DISCUSSION BEFORE THE RADIO SECTION, 16TH NOVEMBER, 1949

Fig. A.—A Nyquist plot of a critically damped resonator.

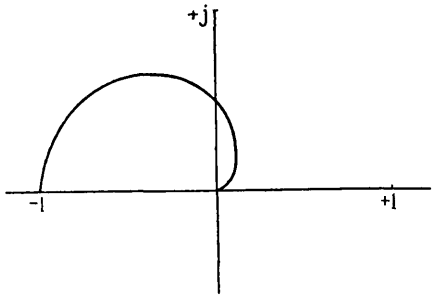
For a typical two-stage amplifier the plot is asymptotic to the 180° axis, and there is some phase margin. If there were more than two stages, the plot would cross the axis and one could speak of amplitude margin. The characteristic in Fig. A repre-

sents a Nyquist plot of a critically damped resonator. How do we know that that represents critical damping, while neighbouring loci on either side represent over-damping and under-damping? Perhaps the author's criterion of stability margin ought to give us the answer; but I doubt this, because I am sure the transient response corresponding to Fig. 9(III) will not be critically damped when it has the same phase margin as Fig. A. Therefore, our "damping margin" has to be some sort of integrated distance from the critical point to a considerable region of the curve, rather than the distance to the nearest point, which is the stability margin.

Fig. B.—The $\mu\beta$ locus of Fig. 7, but with normal valves.

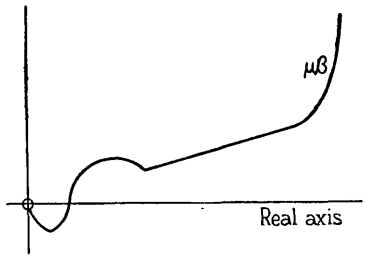
Mr. I. F. Macdiarmid: I should like to make a few remarks concerning the idealized $\mu\beta$ locus shown as curve OXABCD in Fig. 7. This form of locus is suggested as a basis for design, but, in single-loop amplifiers at any rate, it may lead to a serious danger of instability.

The author proposes that the $\mu\beta$ characteristic should be designed with valves at the upper limit of their gain tolerances. The normal tolerance on valve mutual conductance is $\pm$ 2 or $\pm$ 3 db, so that a 3-stage amplifier with normal valves will have a gain of some 6–9 db less than that for which the $\mu\beta$ locus has been calculated. The actual $\mu\beta$ locus will be as shown in Fig. B, where it can be seen that the "constant stability margin" has been lost and the working phase margin is only 15°. As pointed out in the paper, this margin is sufficient to prevent instability, provided the component tolerances do not exceed $\pm$ 10%.

The components which have most effect on the characteristic in the critical region are valve inter-electrode capacitances and

stray capacitances. The normal specified tolerance on valve capacitances is ± 15%, and it seems unlikely that circuit strays can be held to closer limits. The probable variation in capacitance is thus about ± 15% and not the ± 10% required by the author. Using the method of Part 2, Section 3, this capacitance variation can be shown to produce a phase variation of about 4° per *RC* coupling, which amounts to 12° in a 3-stage circuit. Consequently, with normal valves and adverse capacitances, the $\mu\beta$ locus can pass within 3° of the point (1, 0), which, I think the author will agree, is rather close.

Fig. C.—The modified $\mu\beta$ locus with normal valves and 10-db gain margin.

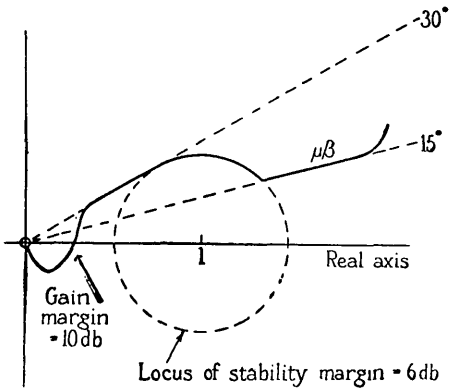
By modifying the author's design procedure slightly it is possible to overcome this difficulty. The modification is to include a separate gain margin in the manner suggested by Bode. To do this the $\mu\beta$ characteristic is designed to be similar to that shown as curve OXABCD in Fig. 7, but using valves of normal gain rather than high gain. Instead of allowing the small arc to cut the real axis immediately, i.e. at (0·5, 0), a gain margin must be included. The actual figure will depend on the valves being used, but for a 3-stage amplifier it will normally be of the order of 9 or 10 db, in which case the $\mu\beta$ locus must not cut the real axis until $|\mu\beta| < 0{\cdot}3$. The type of characteristic so obtained is illustrated in Fig. C. This characteristic does not give what

the author calls a "constant stability margin," but I think it will give a greater margin against instability under average conditions than the characteristic he suggests.

Fig. D.—Basic circuit for measurement of cathode-follower voltage gain.

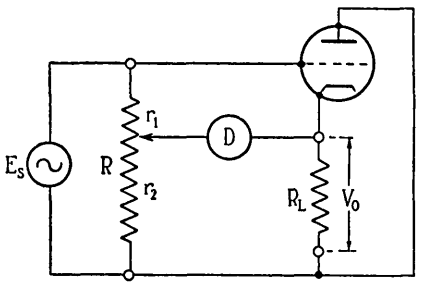
The measurement of cathode-follower gain is illustrated in Fig. D. The theory of the circuit shows that, in the absence of

stray reactances, the potential across the cathode load resistor R_L is in phase with the input signal E_s. Hence, by adjustment of the voltage divider R, a null in the detector current may be obtained. The voltage gain of the amplifier is then simply

If there is appreciable phase shift, the circuit may be modified by the addition of a condenser across either r_1 or r_2, depending upon the sign of the angle.

Fig. E.—Basic circuit for measurement of voltage gain and phase shift of a normal amplifier.

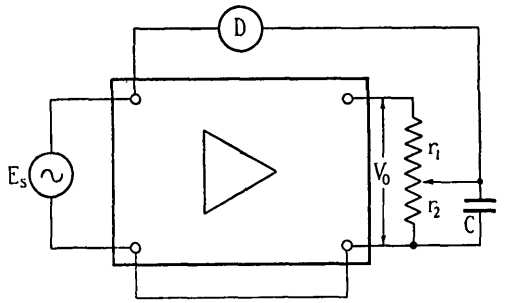
The application of the method to a normal amplifier is illus-

trated in Fig. E. In this case, a fraction of the output voltage is balanced against the input. In the illustration it is supposed that there is an even number of valves in cascade, so that the output voltage V_0 is nominally in phase with the input signal E_s. The phase shift due to stray reactances and inter-valve coupling networks is corrected by the condenser C. When balance is achieved, the gain is given by

In a test at 50 c/s on a 2-stage resistance-capacitance-coupled amplifier, using a vibration galvanometer as detector, agreement of the order of 1 % was obtained between measured and calculated values.

There is a risk that oscillation may occur at some frequency other than the test value, owing to the feedback path provided by the detector. Although the amplifier tested appeared quite stable, it is suggested that the inclusion of a tunable filter in series with the detector would ensure stability.
